ACCESS REPORT

DEVELOPMENT APPLICATION

57-69 STRATHALLEN AVENUE NORTHBRIDGE

MIXED RETAIL / RESIDENTIAL DEVELOPMENT

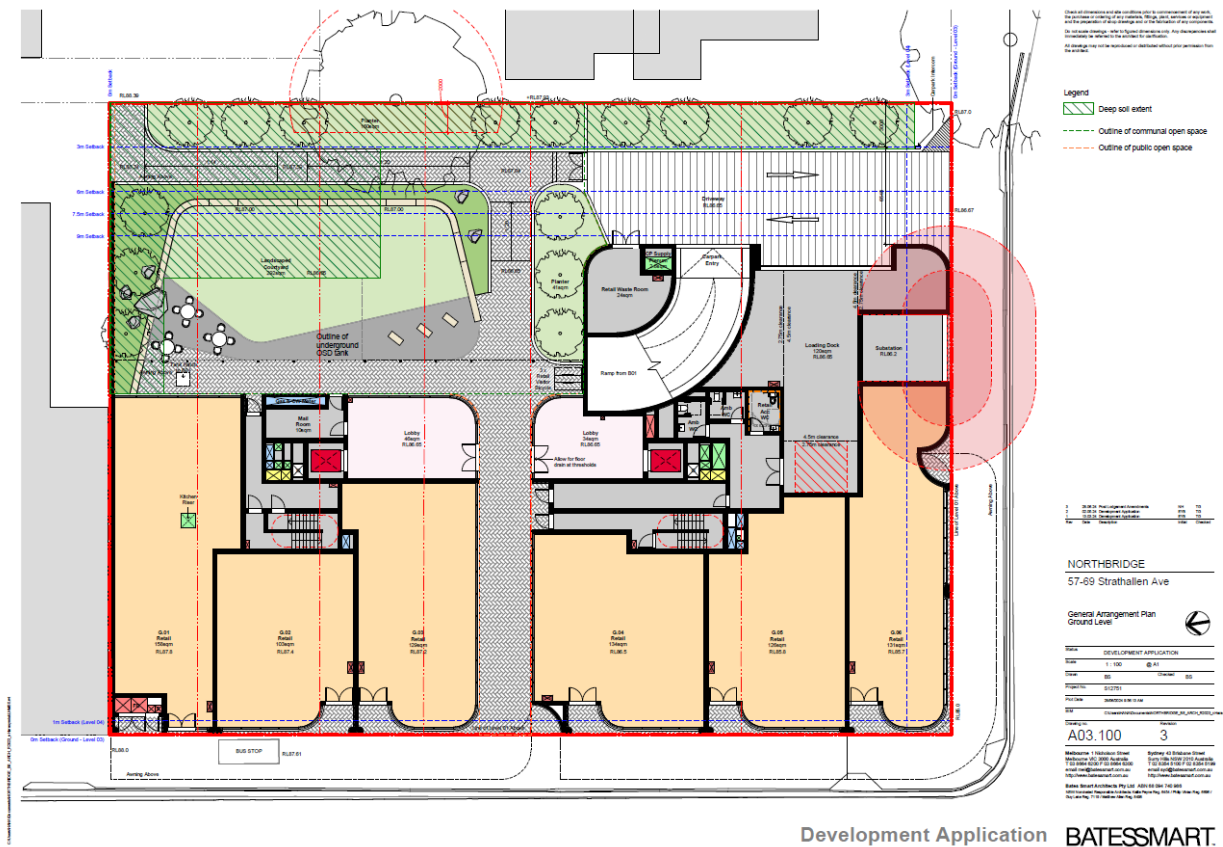
BCA / DDA Premises Standards Review	Complies
1. Ground Floor- A review of the public domain footpath levels indicates accessible entrance thresholds to the central common accessway @RL86.50 and the retail tenancies in accordance with AS1428.1 to comply with clauses D4D2 and D4D3 of the BCA, except retail G.06 @RL85.70 which is elevated approximately 200mm above the footpath, which may require a step ramp and auto opening door.	Can comply

2. The almost level accessway to the residential lift lobbies and communal resident and retail amenities proposes appropriate access in accordance with AS1428.1 to comply with clauses D4D2 and D4D3 of the BCA.	YES

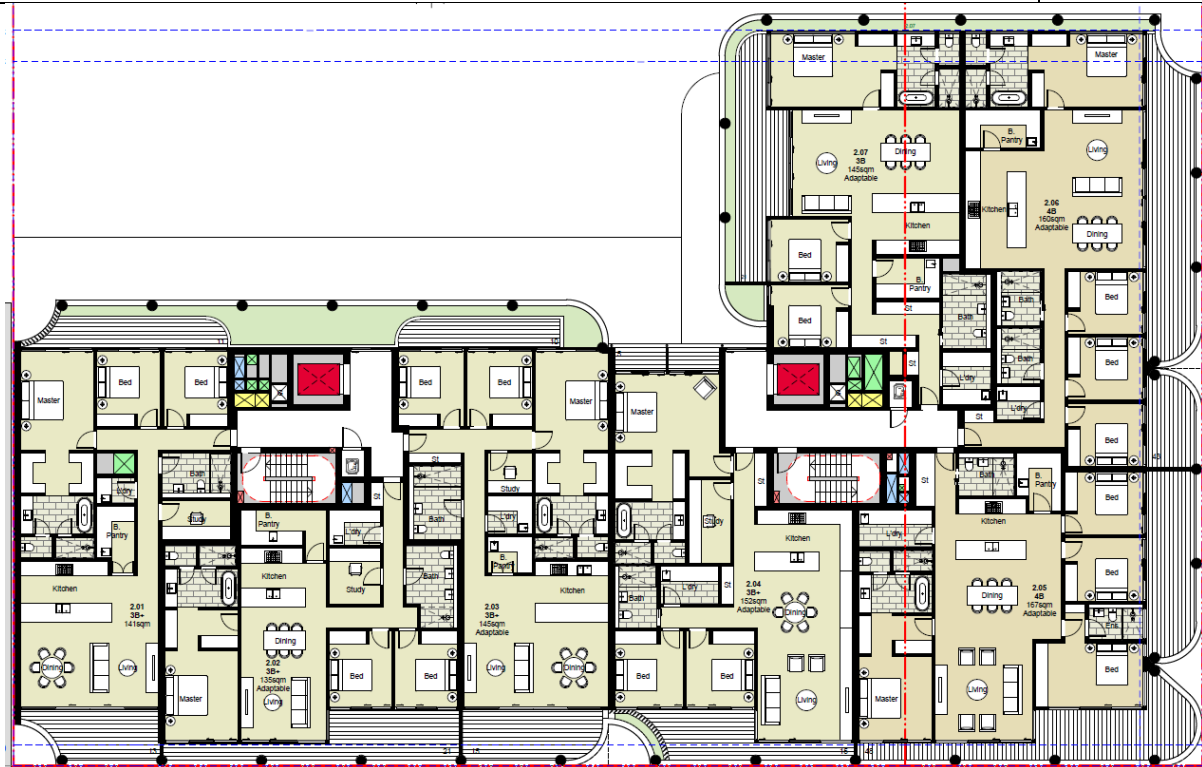
8. Common lift lobbies and basement access is achievable from both common lobbies, and lifts, which propose ample circulation spaces on all levels in accordance with AS1428.1 and satisfy clause D4D4 of the BCA. In particular the 1800mm width lift landings and corridors, which enable turning and passing areas to satisfy clause D4D4 of the BCA.	YES

Level 2-3 (Same lobby designs on levels 1 and 4)

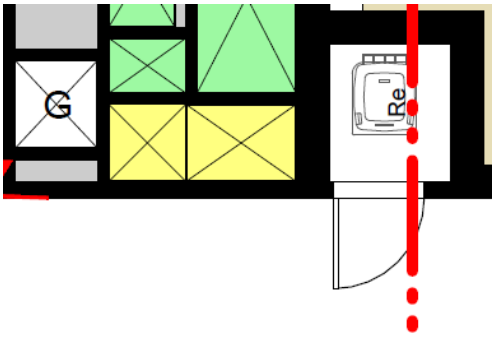
BCA / DDA Premises Standards Review		Complies
<p>9. Residential Bin Rooms & Chutes</p> <p>– The residential levels provide communal bin rooms with garbage chutes and recycle bins on each level adjacent to the lifts, subject to a 920mm outward swing door with a delayed action door closer to enable access for people who use a wheelchair to satisfy clause D4D4 of the BCA.</p>		<p>YES at CC stage</p>

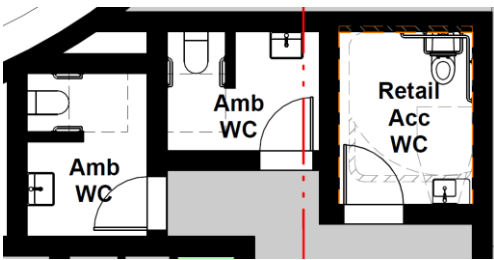
BCA / DDA Premises Standards Review		Complies
<p>10. The basement parking proposes are twenty-four (24) retail spaces on B01 level including two (2) accessible parking spaces on a level surface with direct access to both lifts complying with AS2890.6 which complies with table D4D6 and D4D4 of the BCA.</p>		<p>YES</p>
<p>11. 2200mm minimum entry and driveway aisle heights and 2500mm height clearance over the spaces as required by AS2890.6 to comply with table D4D6 of the BCA.</p>		<p>YES</p>
<p>12. Residential Parking level B02 – Please refer to section B of this report as the BCA does not have any requirements pertaining to residential parking.</p>		<p>N/a</p>

Apartments 2.02, 2.03, 2.04, 2.05, 2.06, 2.07 which are repeated on level 3

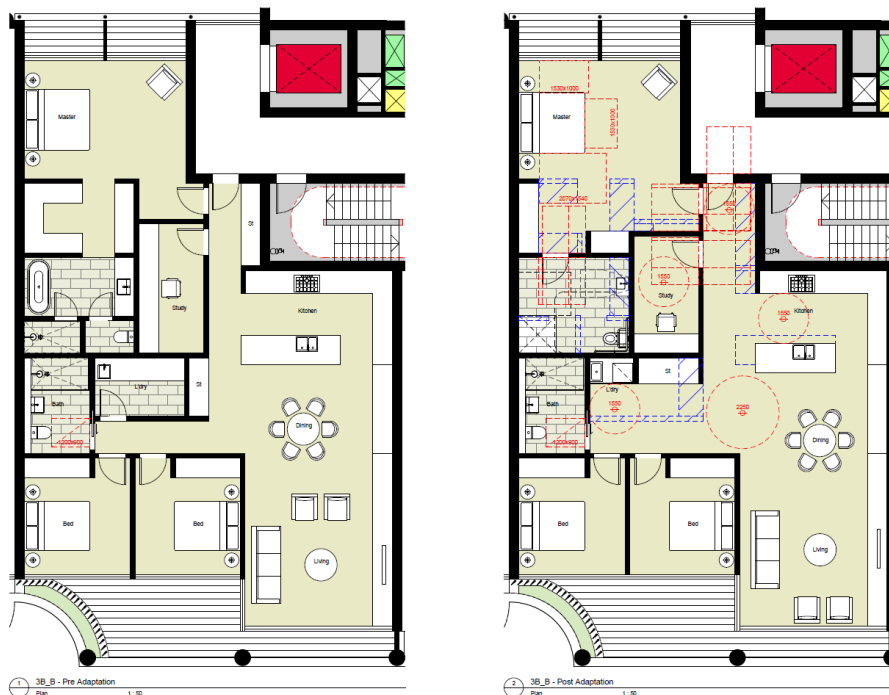
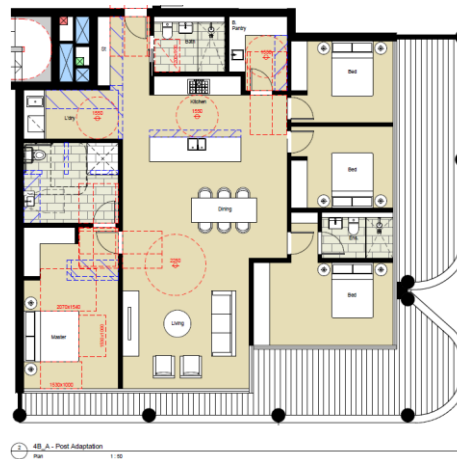
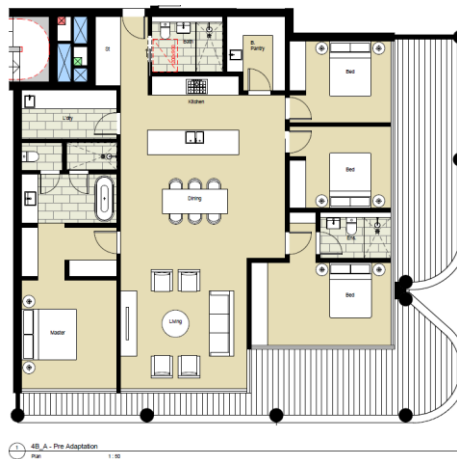
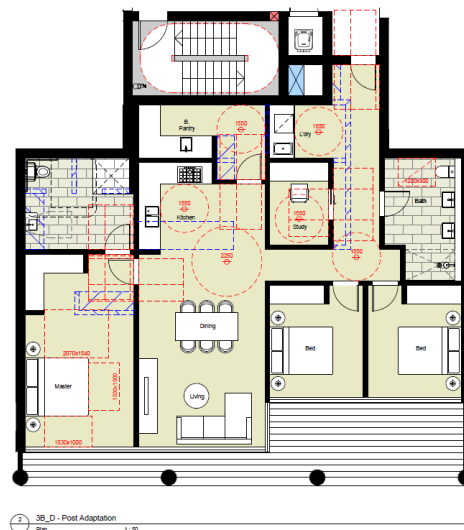
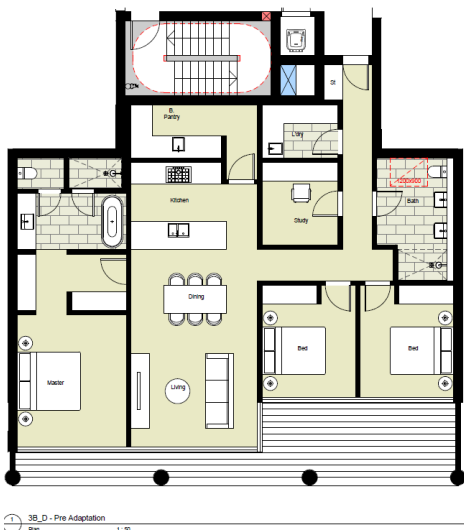
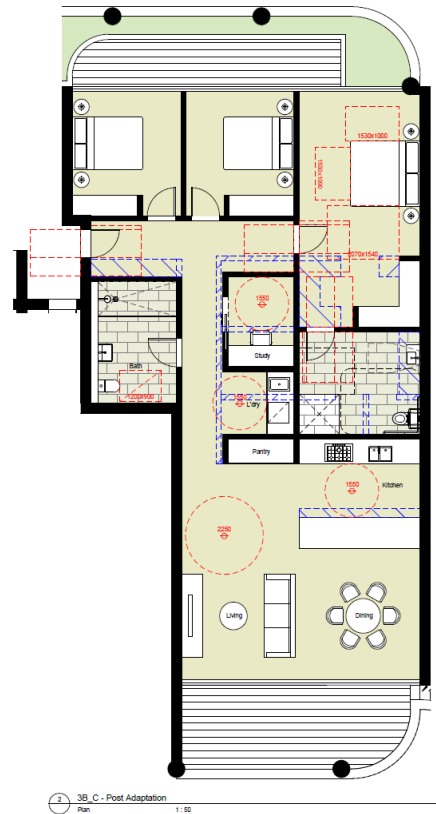
Clause	Adaptability Assessment	Compliance
AS4299 Clause 3.8	Letterboxes Mail Room within the ground floor entrance lobby shows that the development will provide at least 1550mm X 2100mm internal circulation area and access to comply with AS4299.	YES
AS4299 Clauses 3.3 and 3.5	Building Entrances - Ground Floor Residential Lobbies The plans show accessible entrance lobbies on the ground level with an almost level on-grade central accessway from Strathallen Avenue footpath which enable and accessible path of travel to the adaptable apartments. The access to enter the buildings comply with AS1428.1 and AS4299, subject to the detailing of doors, door hardware doorway landings/thresholds, doorway luminance contrast and intercom systems in accordance with AS1428.1. The lift lobbies incorporate multiple lifts that travel to the residential parking levels and the upper residential levels that contain the adaptable units.	YES YES YES at CC stage

AS4299 Clause 3.7	Resident Car Parking The basement car park provides three (3) spaces for the adaptable units that and 2 accessible visitor spaces facilitate 2400mm width adjacent to a 2400mm width shared area consistent with AS2890.6. The designated accessible spaces are required on generally level gradient areas (up to 1:40) with direct access to the northern lifts that facilitate direct access to the adaptable units.	YES YES
 <p>The diagram is a floor plan of Basement B2. It shows three accessible parking spaces, each marked with a wheelchair icon. There are also two accessible visitor spaces. A central area is labeled 'Residential Storage (3 x 15m²)'. To the left, there is a 'WC 7sqm'. The plan also shows lifts and stairs, with some areas highlighted in red and green. The overall layout is designed to provide accessible access to the adaptable units.</p> <p style="text-align: center;">Basement B2</p>		YES

Example pre-adapted unit 2.07

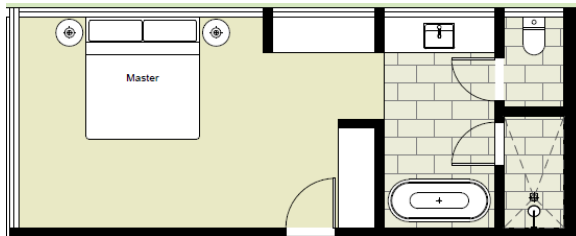
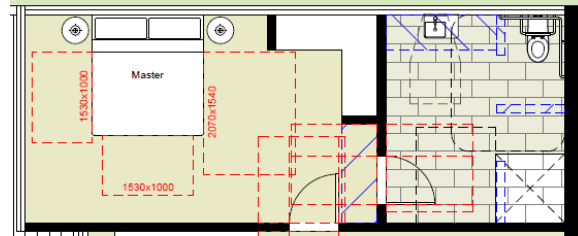
<p>With regard to the “adaptability” of the kitchen the post adaptation plans do not show a wall oven or height adjustable workbench. Although these items can be added at the construction certificate stage to satisfy AS4299.</p>	YES at CC stage
AS4299 Clause 4.6	<p>Main bedroom – The plans show a main bedroom for the adaptable units that require modification to wardrobes and walls to achieve the required circulation spaces around a queen sized bed and doorway. As there are no structural elements in the relocated robes or services then the adaptations comply with AS4299</p>	YES

Clause	Adaptability Assessment	Compliance
	The room sizes allow a circulation area of 1540mm X 2070mm clear of a queen sized bed while maintaining 1000mm clearance on both sides of the bed and clear of a robe to satisfy AS4299. The doorway access to exit the room also complies with AS4299.	YES

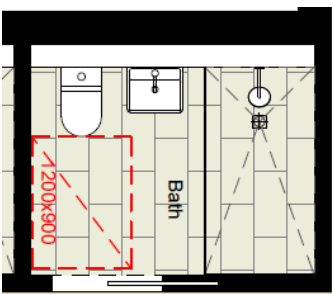
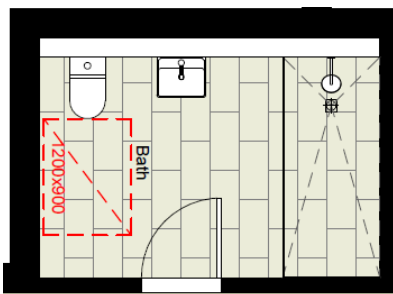
AS4299 Cls 3.5(b)	Outdoor Private Open Space – The plans show outdoor terrace areas adjacent living area with sliding doors. The areas provide adequate space to perform a 180 degree wheelchair manoeuvre.	YES
----------------------	--------------------------------------------------------------------------------------------------------------------------------------------------------------------------------------------------	-----

Detailed construction plans will confirm a step-down in the slab with recessed door track with a wheelchair accessible threshold to the external raised paving to comply with AS1428/4299.
